Mondol Fashion Ltd Shoe Maker Ltd.

Rashid Tower, Tongabari, Asulia, Savar
(23.90585, 90.32248)

8th April 2014

Observations

Tested Columns

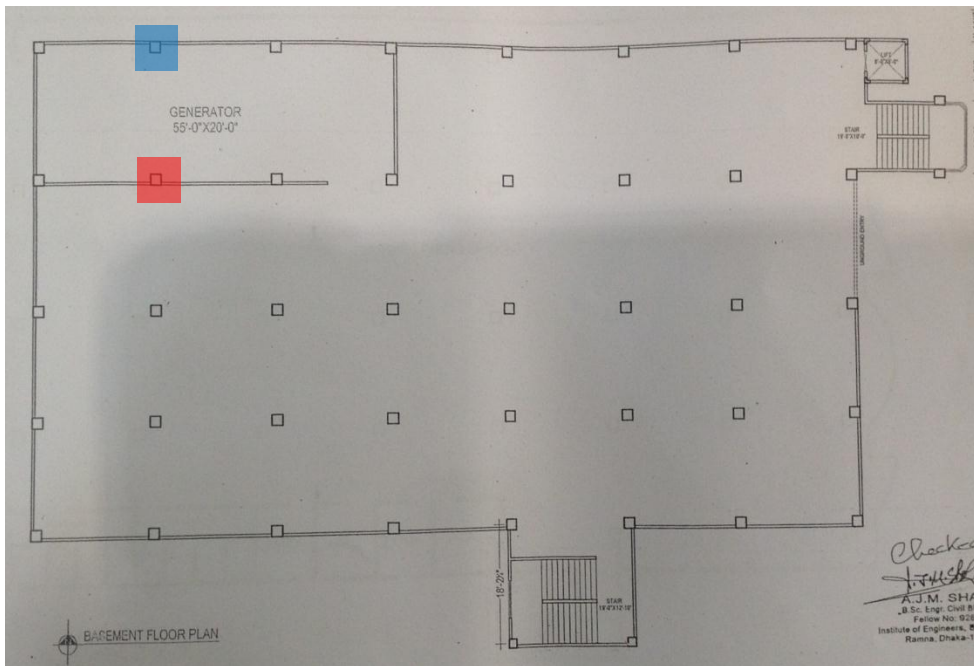
Stress Levels in Columns

Cursory calculations indicate that the working stress of the columns at Ground Floor and First Floor levels are at a high level. Refer to Action 1.

Exposed Column A/2

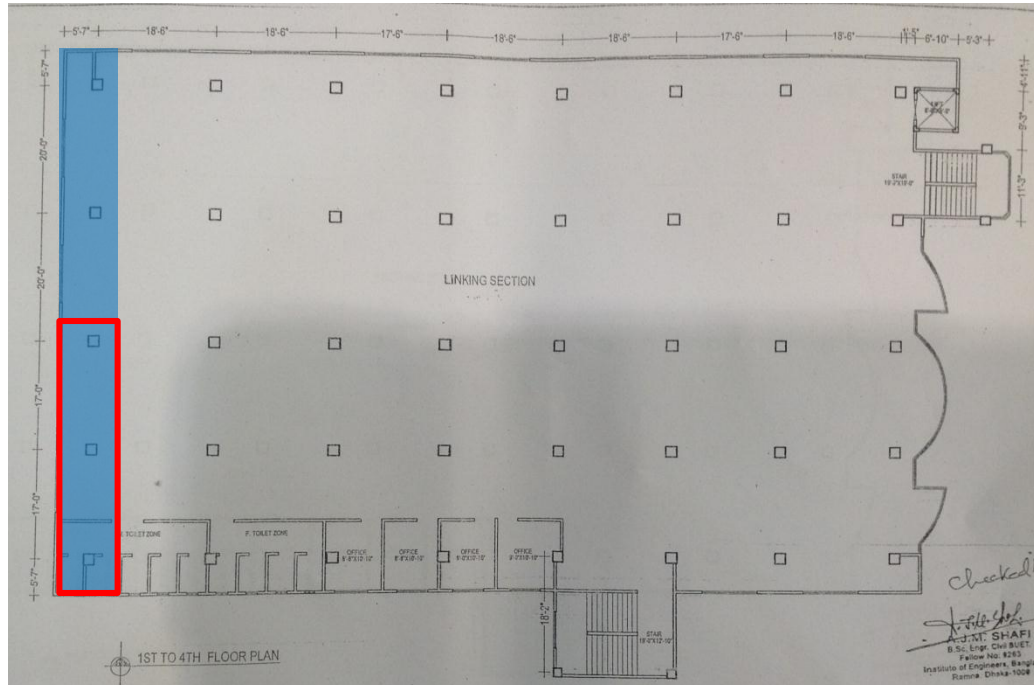
High strength reinforcement steel bars were observed at Roof level. The number of bars observed at Roof level is comparable with observations at basement level using the ferros scanner, but is inconsistent with what is indicated in the Structural Drawings.

Hairline cracks were noted to column head. This prompted the removal of plaster, which revealed different aggregate types used in distinct concrete pours for the same column.

Typical Floor Plan

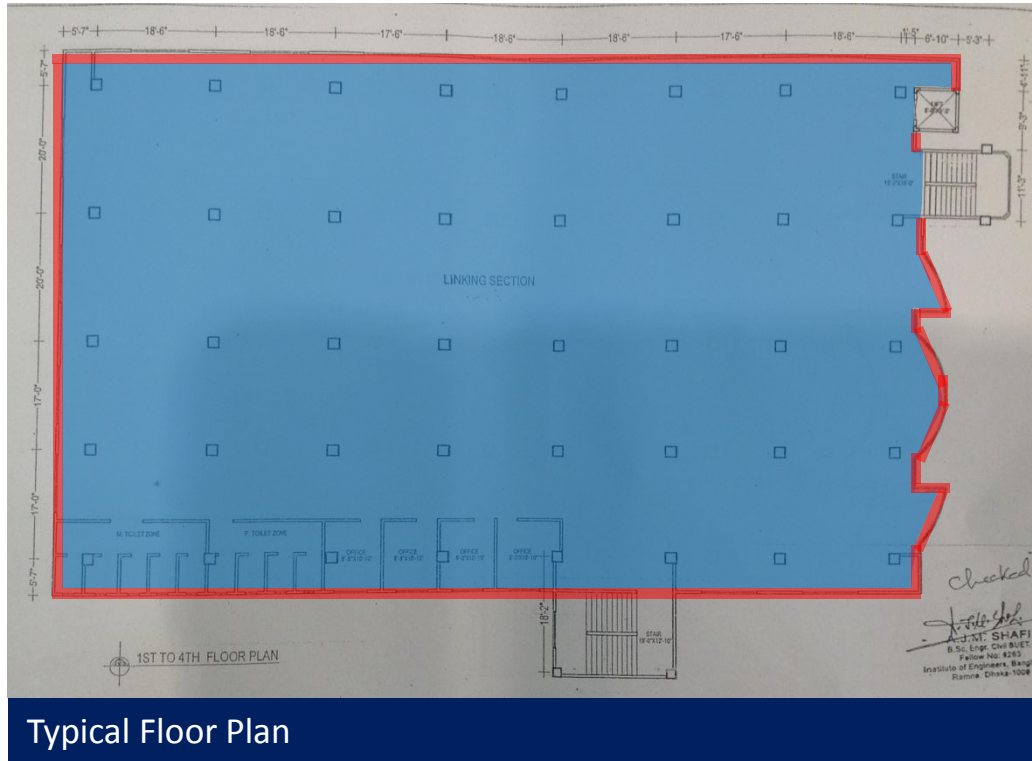
Heavy floor loading in toilet areas

Areas of high super dead loading were noted in the toilets along the West elevation of the building at the cantilever location, in the form of plinths, suspended slabs and walls. Building Engineer to check that the cantilevers have been adequately designed to accommodate this loading.

Edge Protection

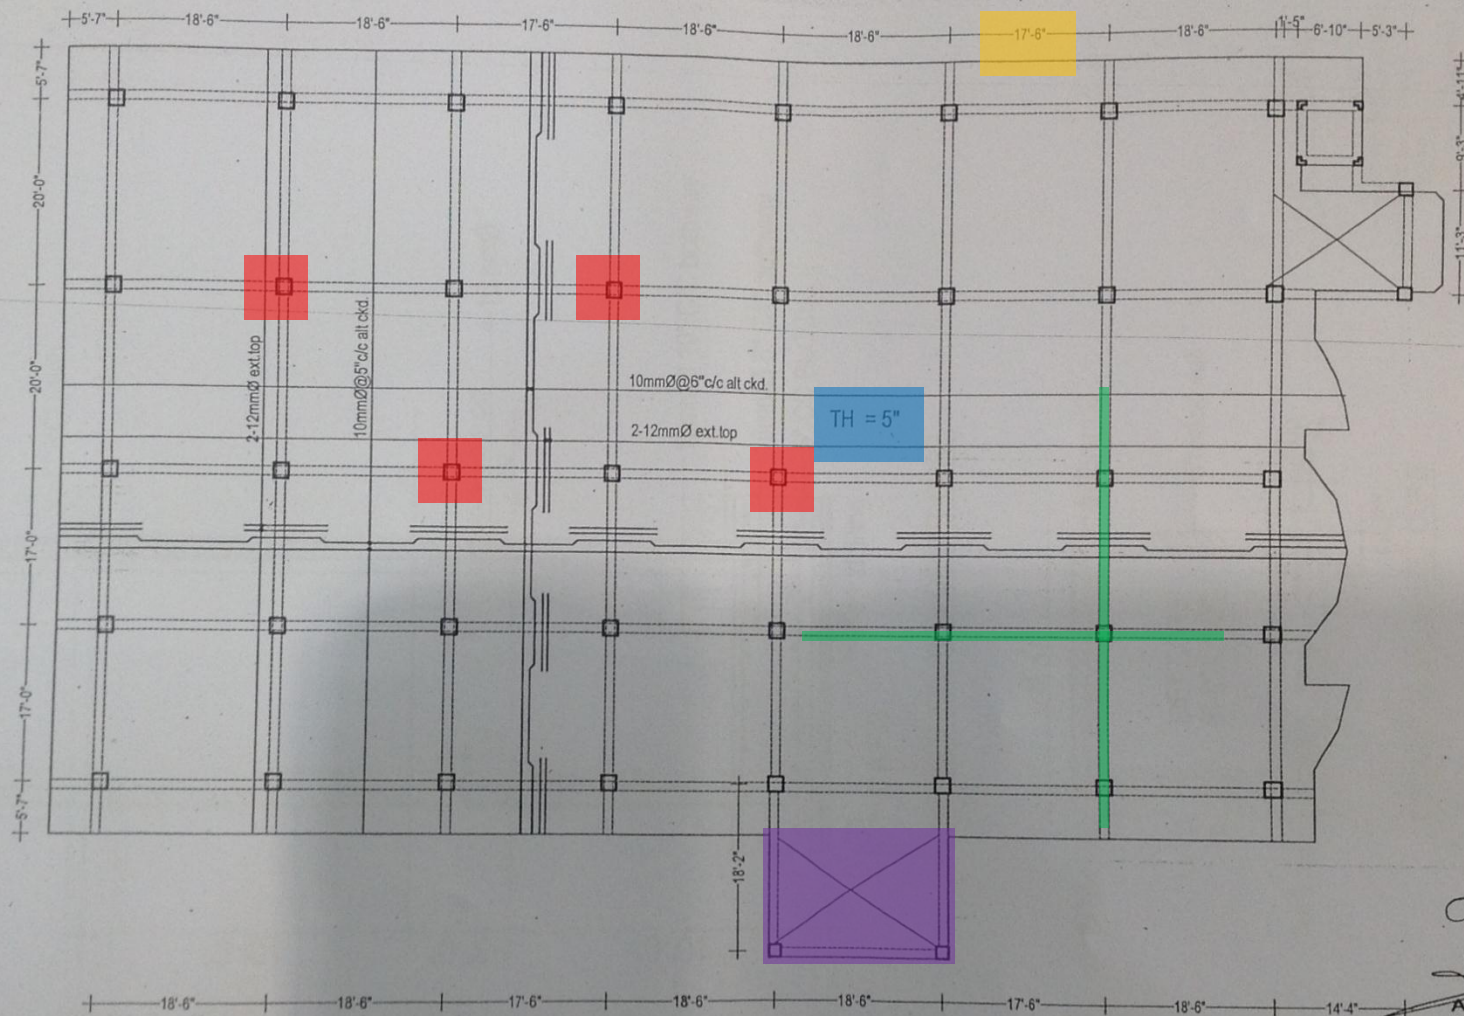
Lack of any guarding / edge protection at Roof Level and at some stairs levels

There is no edge protection at Roof level where works are ongoing. Handrails are also missing to stairs. Building Engineer to install adequate fall barrier / guarding with immediately effect.

Typical Floor Plan

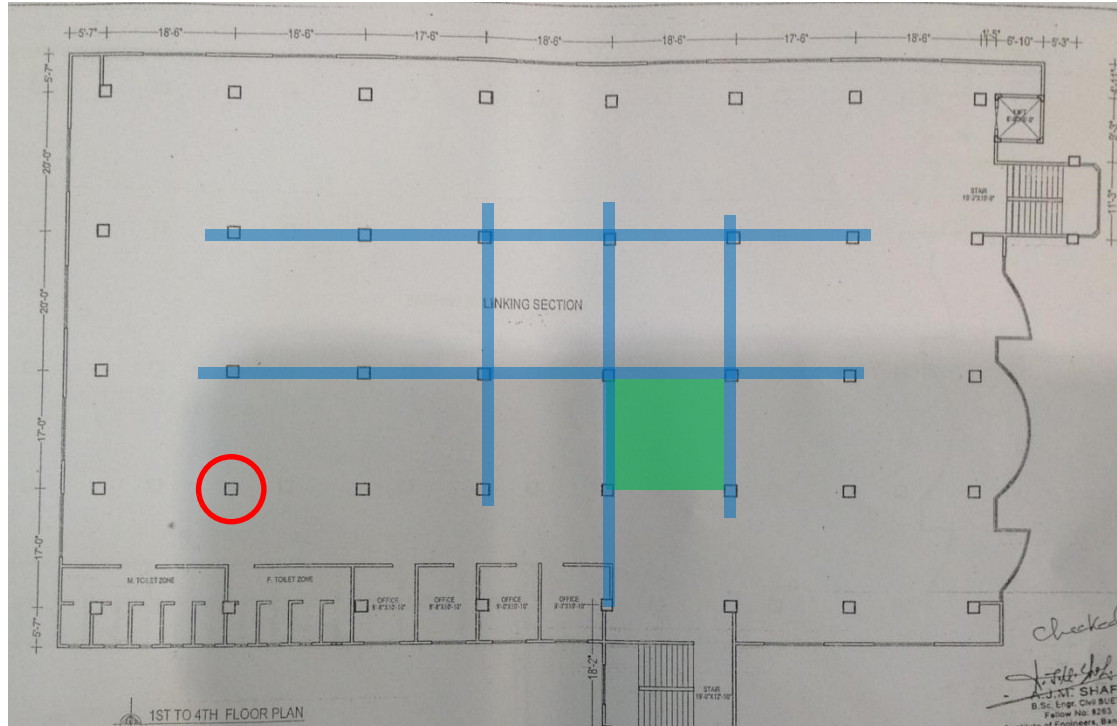
Differences between actual construction and information on design drawings

A set of Structural Drawings (undated), by EMO Consulting Engineers, which appeared to be original, was made available for review on the day of the survey. There are a number of inconsistencies between drawings and constructed building. A non-exhaustive list of issues include:

- Incorrect column sizes, particularly at Ground Floor level where the uniformity in internal column size indicated in the drawings is not apparent;
- Incorrect column reinforcement – the number of bars observed at Roof level, and again at Ground Floor level using the Ferroscanner, was not in accordance with the drawings;

- Inconsistent construction type – the drawings appear to indicate beam and slab construction, whereas flat slab with perimeter beam is observed at 1st Floor level, flat slab at 2nd and 3rd Floor levels, and beam and slab thereafter;

- Inconsistency with aggregate type – stone aggregate is referenced in the drawings, whereas it is understood that brick aggregate has been used in all structural elements other than columns to 2nd Floor level.

- Slab thickness is called up as 5” in the drawings, whereas a minimum of 6” is observed;
- The layout of the south facing staircore does not appear to be in the correct location.

Building Engineer to review and provide clarification.

Typical Floor Plan

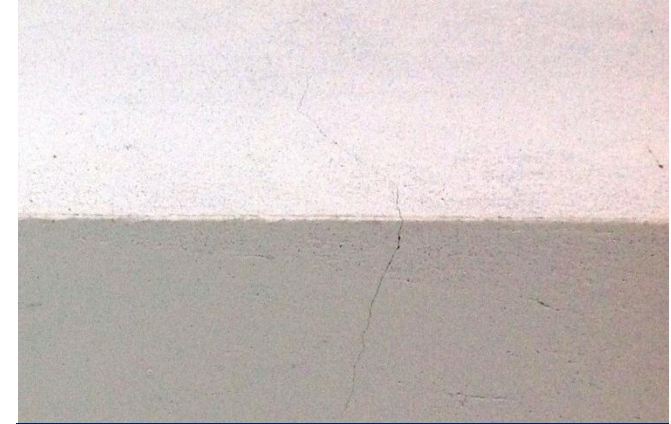
Hairline cracking on beams and some slab soffit areas

Hairline cracking was observed to the soffit of a number of beams and slabs at Ground, 2nd, 3rd, and 4th Floor levels. Building Engineer to investigate and carry out remedial works to the structure as required.
